PREVOST

SAFETY RECALL

Sr01-07

DATE : OCTOBER 2001	SECTION : 14
SUBJECT : STEERING GEARBOX SUPPORT REINFORCEMENT

FIGURE 2

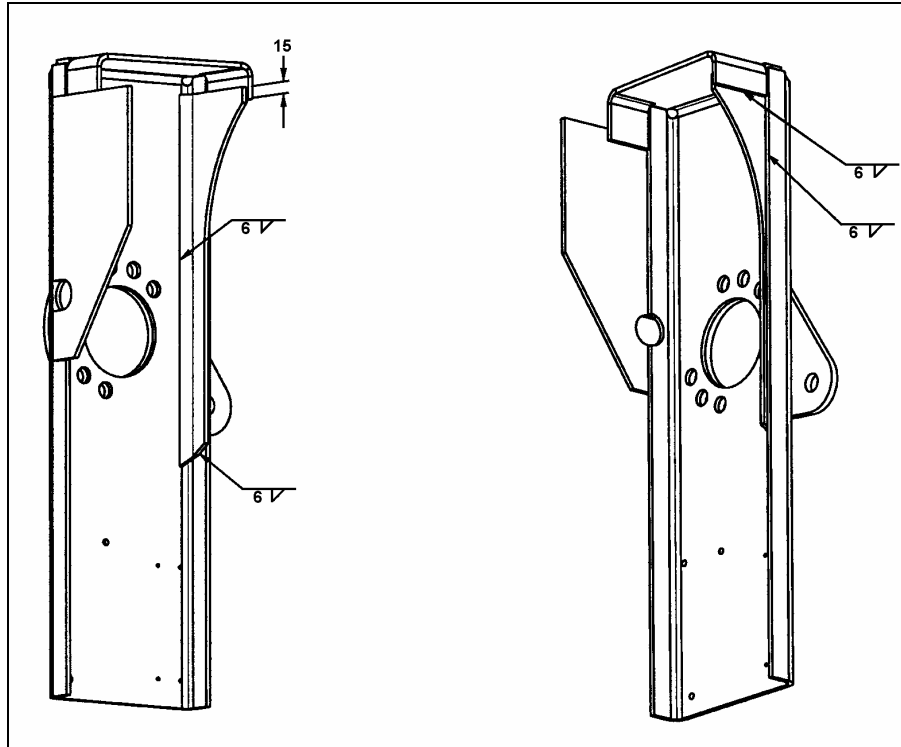
7. Using a grinder, clean the seating surfaces of the support to ensure adequate seating of the reinforcement part. Seat reinforcement part on support as per figure 2 and hold with a C-clamp "Vise-grip".
8. To perform welding, refer to figure 2 and welding specifications indicated in paragraph: **Steel – Steel Welding.**
9. Reconnect components mentioned at step 6.

Caution: Verify that pitman arm does not interfere with structure.

IMPORTANT : If cracks are present, you must contact the nearest Prévost authorized service center to have the repair performed.

- FCAW (Flux Cored Arc Welding) process ;
- Electrode wire conforms to A5.20 AWS (American Welding Society) specifications ;
- E4801T-9-CH, type electrode wire with 0,045" diameter (1,14 mm) ;
- Voltage : 26 ± 1 volts ;
- Current : 260 Amps ;
- Wire feed rate : 450 ipm. approx. ;
- Shielding gas : 75% argon - 25% CO₂ or 100% CO₂.

FIGURE 3

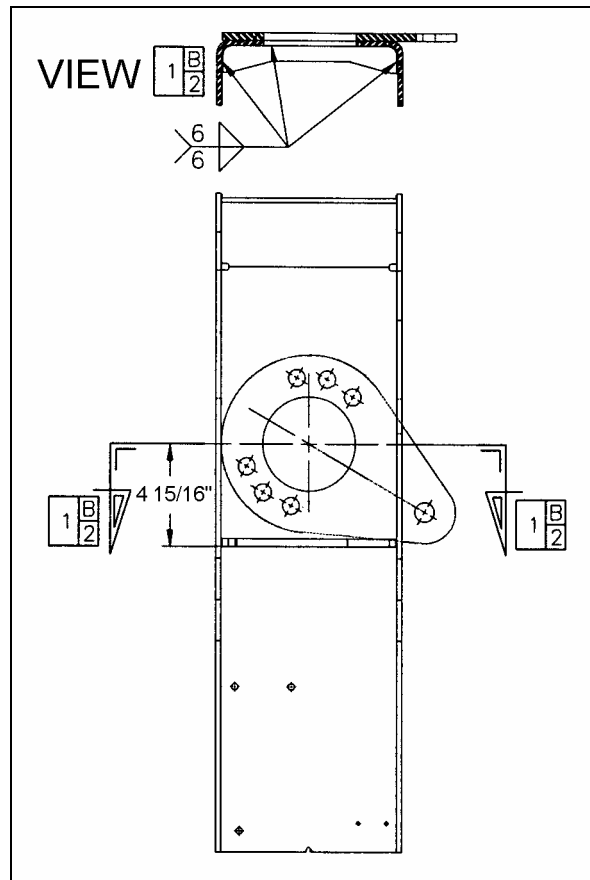
- Do not connect welding cables to electronic control components.
7. Using a grinder, clean the seating surfaces of the support to ensure adequate seating of the reinforcement part. Seat reinforcement part on support as per figure 2 and hold with a C-clamp "Vise-grip".
 8. To perform welding, refer to figure 2 and welding specifications indicated in paragraph: **Steel – Steel Welding.**
 9. Reconnect components mentioned at step 6.

Caution: Verify that pitman arm does not interfere with structure.

IMPORTANT : If cracks are present, you must contact the nearest Prévost authorized service center to have the repair performed.
